May 25, 2021  
WO 21-0015

Subject: Docket No. 50-482: License Amendment Request (LAR) for Revision to the  
Emergency Plan

Enclosures: I Proposed Markup of Procedure AP 06-002, Radiological Emergency Response Plan (RERP)  
II Revised (clean copy) Procedure AP 06-002, Radiological Emergency Response Plan (RERP)  
III Wolf Creek Nuclear Operating Corporation On-Shift Staffing Analysis, Draft Revision 2

FIGURE 2  
MINIMUM SHIFT STAFFING

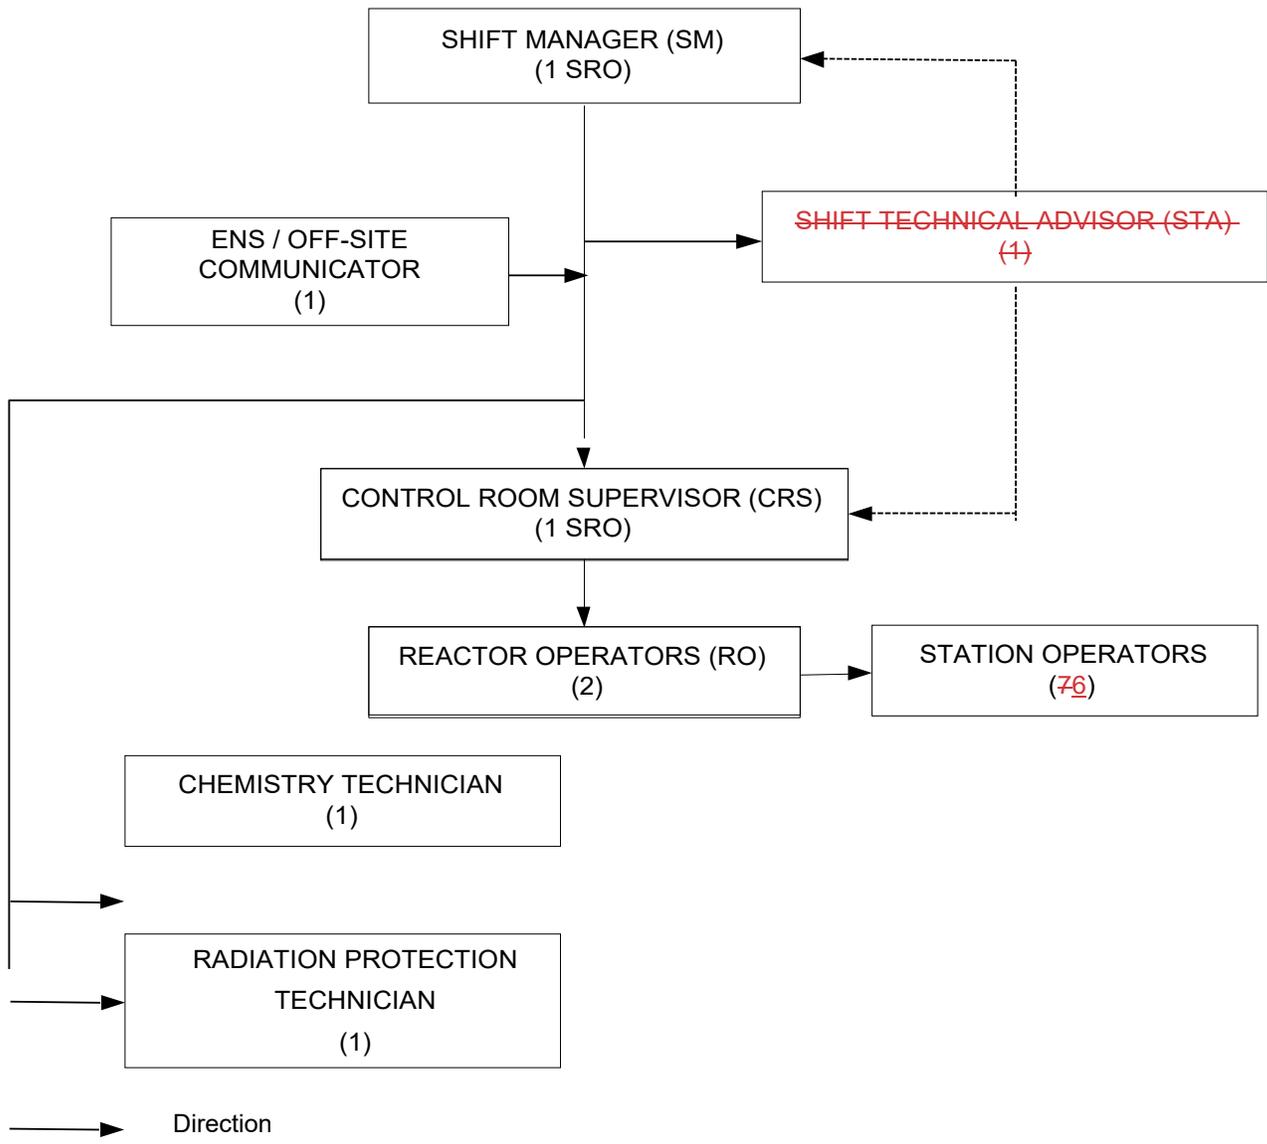
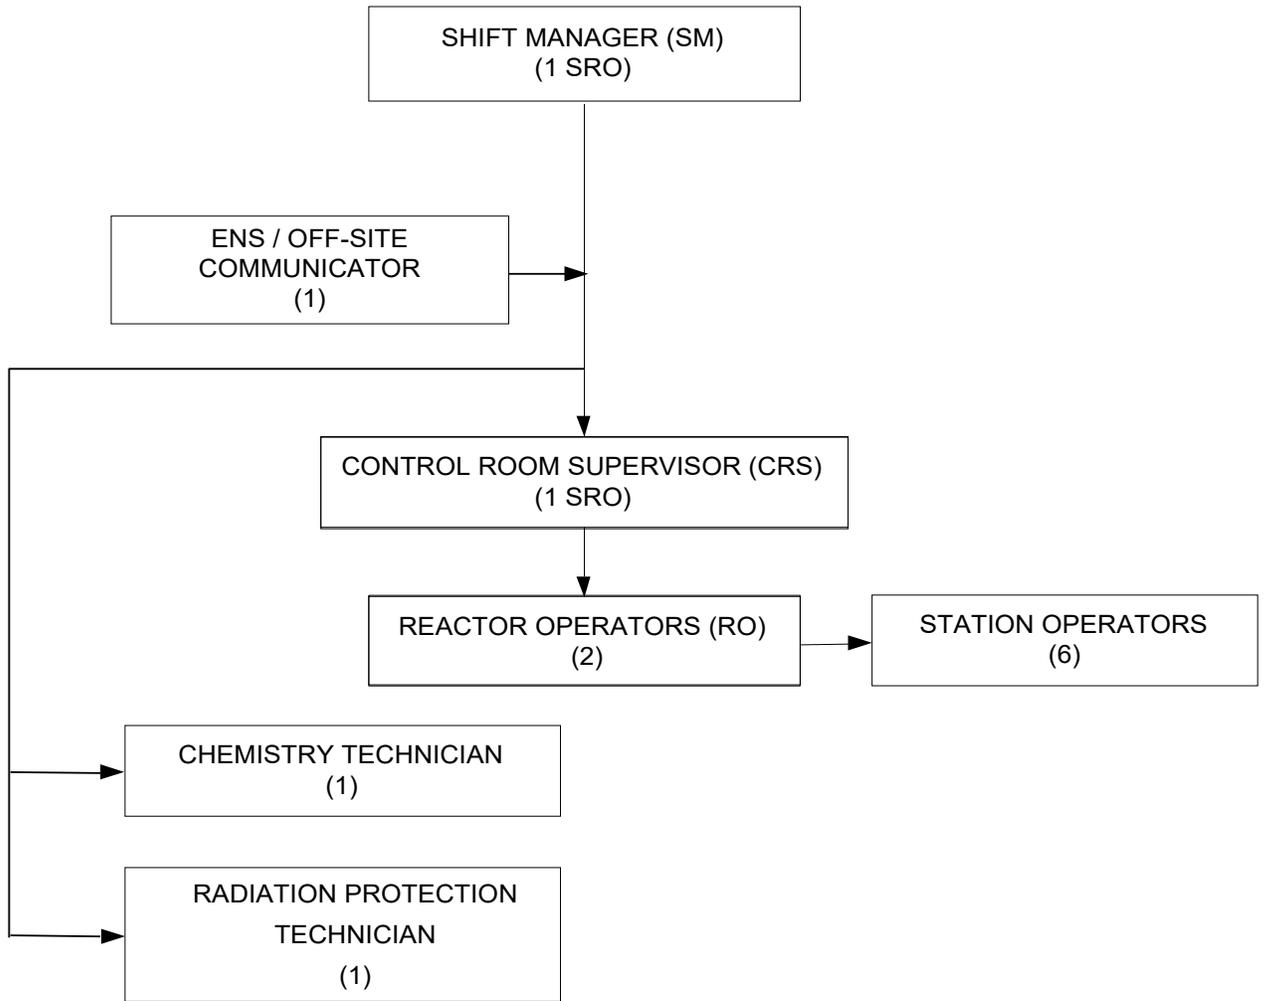
RERP Section	Before (Rev. 21)	After (Pending Revision Number)	Reason for Change
Figure 2, Minimum Shift Staffing	<p><u>NOTE</u>  STA is required in Modes 1-4. An SRO capable of performing STA functions is required in Modes 5, 6 and defueled.</p>	Delete NOTE	This amendment will eliminate a dedicated shift technical advisor (STA) position by allowing the STA functions to be combined with one or more of the required senior licensed operator positions (dual role SRO/STA – Option 1 of GL 86-04).
Figure 2, Minimum Shift Staffing	<p>Block labelled <u>SHIFT TECHNICAL ADVISOR (STA) (1)</u>  and  STA = Shift Technical Advisor</p>	Deleted	This amendment will eliminate a dedicated shift technical advisor (STA) position by allowing the STA functions to be combined with one or more of the required senior licensed operator positions (dual role SRO/STA – Option 1 of GL 86-04).

**NOTE**  
~~STA is required in Modes 1-4. An SRO capable of performing STA functions is required in Modes 5, 6 and defueled.~~
